Access Compliance Report

Public Rights-of-Way

Intersection ID: 43075	Main Street: SCOTT_AV	Cross Street: ROMANY_RD	Location: W
ADA ID: CF49944F3298	Ramp Type: Perp	Initial Pass/Fail: Fail	Overall Compliance: No
			Severity Score: 21.25

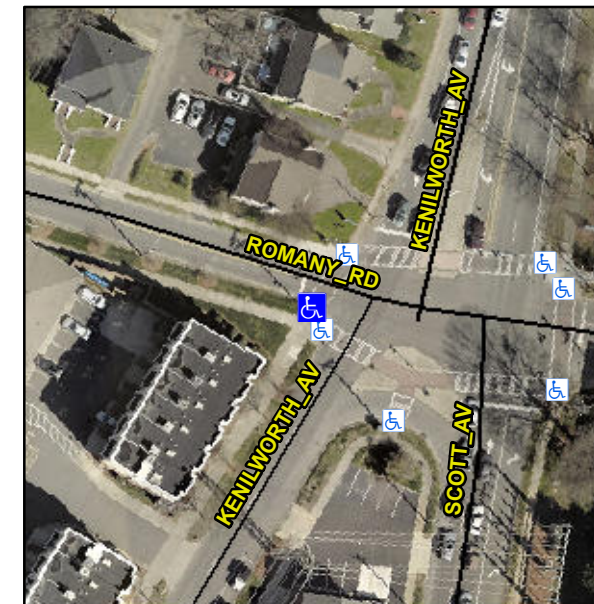
R304.5.1, R304.5.3

Compliance	Description	Data	Compliance	Description	Data
N/A	Ramp Length (in)	94.0	Yes	Ramp Slope (%)	7.4
No	Ramp Width (in)	47.0	No	Ramp XSlope (%)	5.4
N/A	Flare Type LT	N/A	N/A	Flare Type RT	N/A
N/A	Flare Slope LT (%)	N/A	N/A	Flare Slope RT (%)	N/A
N/A	Flare Traversable LT?	N/A	N/A	Flare Traversable RT?	N/A
N/A	Landing Length (in)	N/A	N/A	DWS Provided?	N/A
N/A	Landing Width (in)	N/A	N/A	DWS Contrast?	N/A
N/A	Landing Slope (%)	N/A	N/A	DWS Length (in)	N/A
N/A	Landing X Slope (%)	N/A	N/A	DWS Full Width?	N/A
N/A	Landing Curb? (Y/N)	N/A	N/A	DWS Offset (in)	N/A
N/A	Shared Landing?	N/A			
N/A	Gutter Ponding?	N/A	N/A	Gutter Slope (%)	N/A
N/A	Gutter Lip Ht (in)	N/A	N/A	Gutter X Slope (%)	N/A
N/A	Painted X Walk1?	Yes	N/A	Painted X Walk2?	N/A
	X Walk 1 Direction	To NE		X Walk 2 Direction	N/A
N/A	X Walk 1 Width (in)	106.0	N/A	X Walk 2 Width (in)	N/A
	X Walk 1 Slope (%)	6.0		X Walk 2 Slope (%)	N/A
	X Walk 1 X Slope (%)	2.1		X Walk 2 X Slope (%)	N/A

Remove & Replace Entire Ramp.
